Project Name: Powers & Palmer FSU 05934
Project Address: 5813 Palmer Park Blvd, Colorado Springs, CO 80915

RE: El Paso County – Site Plan Review - RESPONSE LETTER, 2nd Review
Permit No.: PPR2521

P4. LOI Page 1

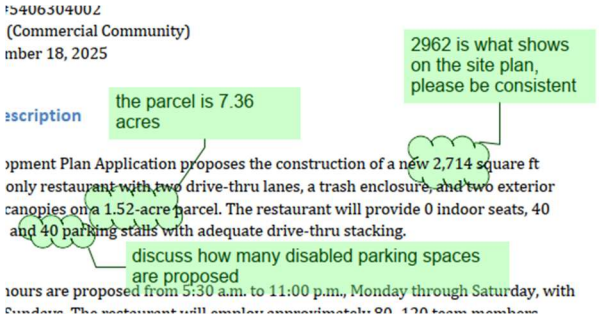
*** REVISE***
Most of this letter seems to be discussing a property within the City Planning jurisdiction and referencing the Unified Development Code. Please revise and discuss the property on Palmer Park and Powers and how the design complies with the Land Development code and resubmit for re-review.

Applicant Response [4G]: LOI revised to discuss Chick-fil-A property and El Paso County Land Development Code.

E4. FAE Page 1

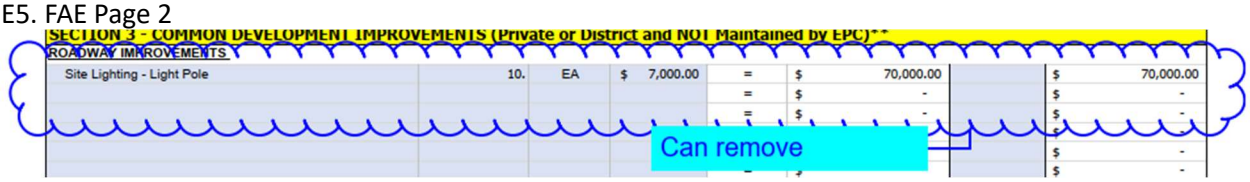
Permanent Seeding (inc. noxious weed mgmnt.) & Mulching	.44	AC	$ 2,169.00	=	$ 954.36	
Permanent Pond/BMP (provide engineer's estimate)		EA				
Concrete Washout Basin	1.	EA	$ 1,260.00	=	$ 1,260.00	
Inlet Protection	3.	EA	$ 233.00	=	$ 699.00	
Rock Check Dam		EA	$ 700.00	=	$ -	
Safety Fence	3318.	LF	$ 3.00	=	$ 9,954.00	
Sediment Basin		EA	$ 2,466.00	=	$ -	
Sediment Trap	1.	EA	$ 578.00	=	$ 578.00	
Silt Fence	3336.	LF	$ 4.00	=	$ 13,344.00	
Slope Drain		LF	$ 46.00		$ -	
Straw Bale		EA	$ 35.00	=	$ -

Applicant Response [Merrick]: FAE FORMED UPDATED TO 2026 FORM
Detail No./Sheet No.: PAGE 1

E12. FDR Page 11

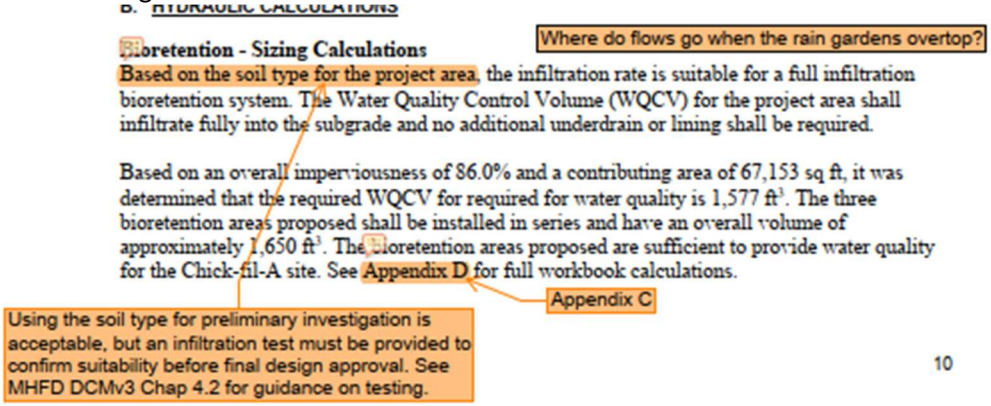
Provide road side ditch profile and capacity analysis

Applicant Response [Merrick]: ROAD SIDE DITCH PROFILE AND CAPACITY ANALYSIS PROVIDED
Detail No./Sheet No.: APPENDIX
